**PLANNED UNIT DEVELOPMENT****Date: August 6, 2009****DEVELOPMENT NAME**

Valenti Southeast Realty

Planned Unit Development Approval to allow reduced front yard setbacks for a restaurant.

*Revised for the September 3<sup>rd</sup> meeting:*

# SITE PLAN

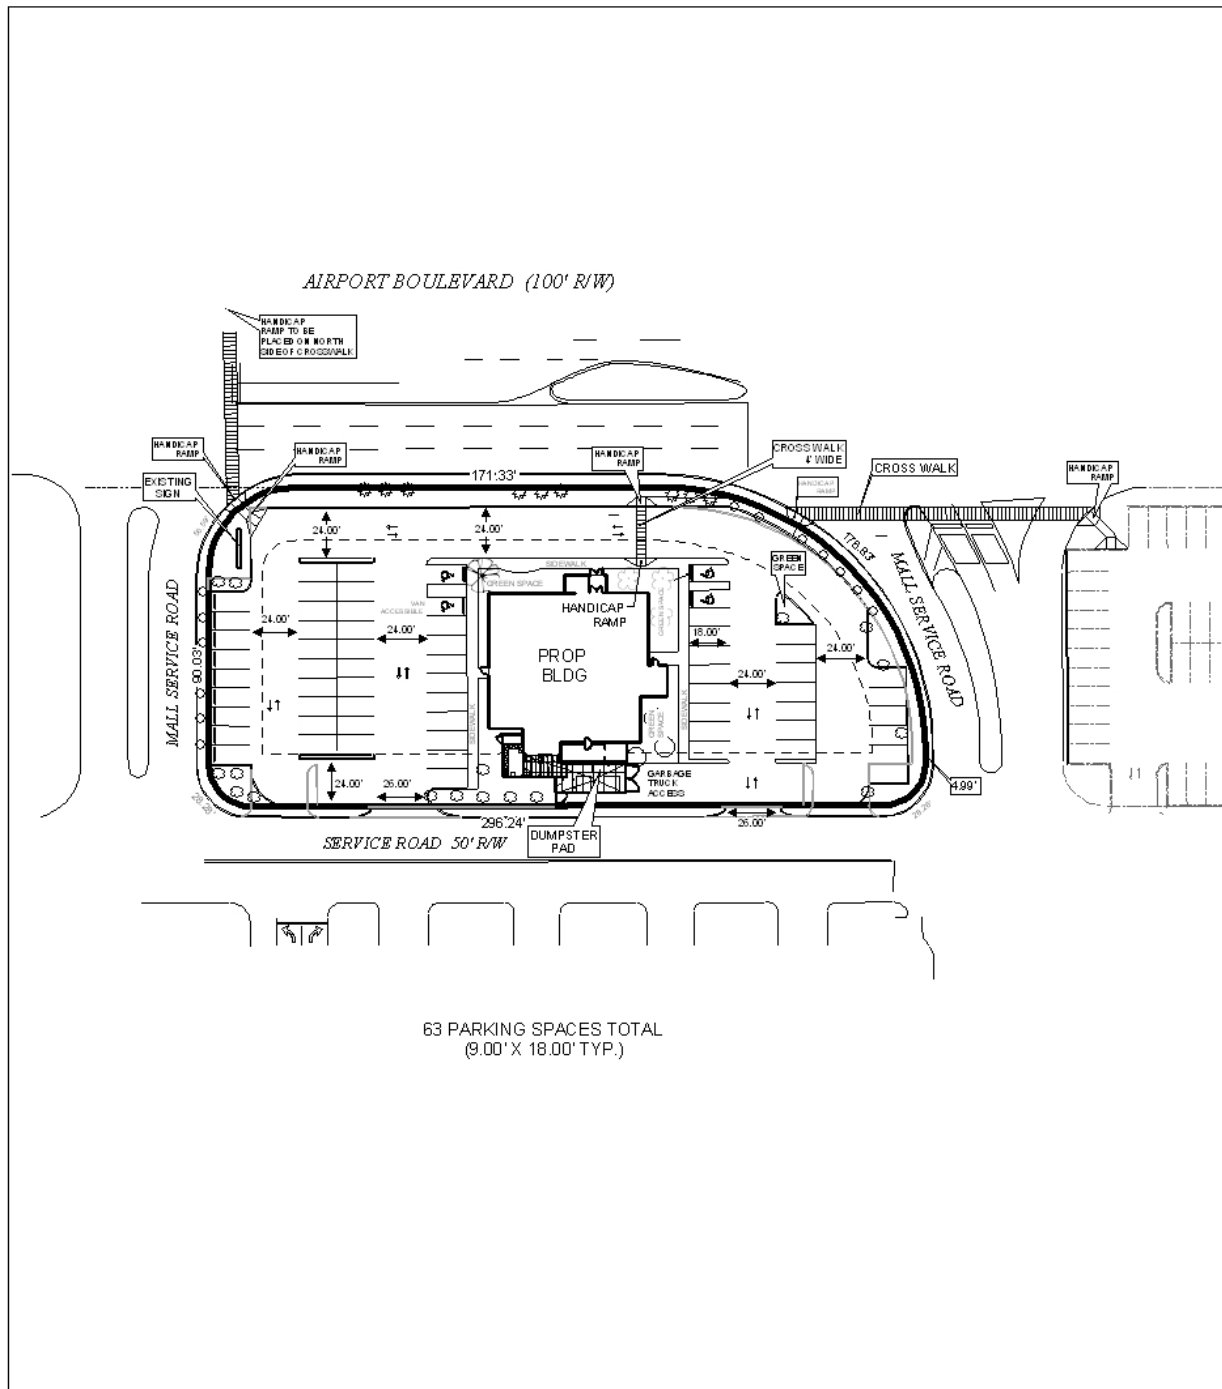
The applicant is requesting a reduction in the required 25-foot building setback along the Southern boundary to accommodate the proposed 6,270 square foot restaurant. The main portion of the building will be approximately 13 feet from the Southern property boundary; however, the enclosure for the dumpsters will be only 6 feet from the Southern property boundary. The site plan submitted is almost identical to the site plan submitted with the previous PUD for this site, but with some minor changes incorporating conditions of approval of the previous PUD. It now indicates a 25-foot minimum building setback line from all street frontages, except for where the building and dumpster enclosure would encroach into the normal setback. As per the 2008 approval of the Sidewalk Waiver, pedestrian crosswalks are proposed across Airport Boulevard at the Northwest corner of the property, and across the North entrance to the mall service road on the East side of the property. The relocation of the existing Airport Boulevard cross walk at the Northeast corner to the Northwest corner of the site is in agreement with the Traffic Engineering Comments. Handicap ramps should meet current ADA requirement and City of Mobile standards. Crosswalks and any other proposed striping changes should meet MUTCD standards.

It also appears that some of the curbing associated with the parking area may cross the property boundary on the South and West sides. Any new construction must take place fully within the property, with the exception of the proposed pedestrian cross walks.

The site plan depicts the building and 63 parking spaces. Interior circulation appears to meet minimum dimensional requirements as it relates to the width of access aisles, but the layout of the parking does not appear to provide much accommodation for vehicular turning radii, thus setting the stage for congestion and accidents on the site during parking maneuvering and circulation – thus the site *may* be being overbuilt. The congestion caused by the site design may result in back-ups into adjacent roads. The number of parking spaces, however, *does* meet the minimum quantity requirements for the restaurant. Bumper stops are indicated in the West side parking stalls to prevent parked vehicles protruding into the right-of-way adjacent to the stalls.

As previously mentioned, the site has frontage on Airport Boulevard, Airport Boulevard Service Road, and two mall entrance drives, all of which are public streets with adequate rights-of-way. Since Airport Boulevard is a proposed major street, and as the site is entirely bounded by streets, access management for the site is a concern. Traffic counts from June 2009 indicate that approximately 28,748 vehicles per day passed the site along Airport Boulevard. The site plan submitted with the application indicates the two existing curb cuts onto the Airport Boulevard Service Road are to be closed and replaced with two new curb cuts onto the same aligning with internal traffic aisles, as per the 2008 PUD approval conditions. Staff believes that two curb-cuts are appropriate for the site, and that the location of the curb-cuts along the Southern boundary would be most appropriate for the site due to the high traffic volumes along Airport Boulevard as well as the entrance and exit roads for the mall property. Therefore the site should be limited to a maximum of two curb-cuts along the Southern boundary of the property. The size, design and location of the new curb-cuts are to be approved by Traffic Engineering and designed in conformance with AASHTO standards. The existing curb cuts which are removed should be landscaped to match adjacent right-of-way.

- 1) the site is limited to the two proposed curb cuts to the Airport Boulevard Service Road;
- 2) subject to the Traffic Engineering Comments: *(Driveway number, size, location, and design to be approved by Traffic Engineering and conform to AASHTO standards. Handicap ramps and crosswalks will be the responsibility of the developer, with their location and design to be coordinated with Traffic Engineering. The crosswalk on the northeast side of the development should be relocated to the northwest side of the development where there are existing pedestrian signals. Handicap ramps should meet*

- 3) existing curb cuts are to be closed with curbing and landscaping to match adjacent right-of-way;
- 4) the site is denied any curb cuts onto Airport Boulevard;
- 5) full compliance with the landscaping and tree planting requirements; and
- 6) subject to the Engineering Comments: *(Must comply with all storm water and flood control ordinances. Any work performed in the right of way will require a right of way permit. Drainage from any new dumpster pads cannot discharge to storm sewer; must have connection to sanitary sewer).*
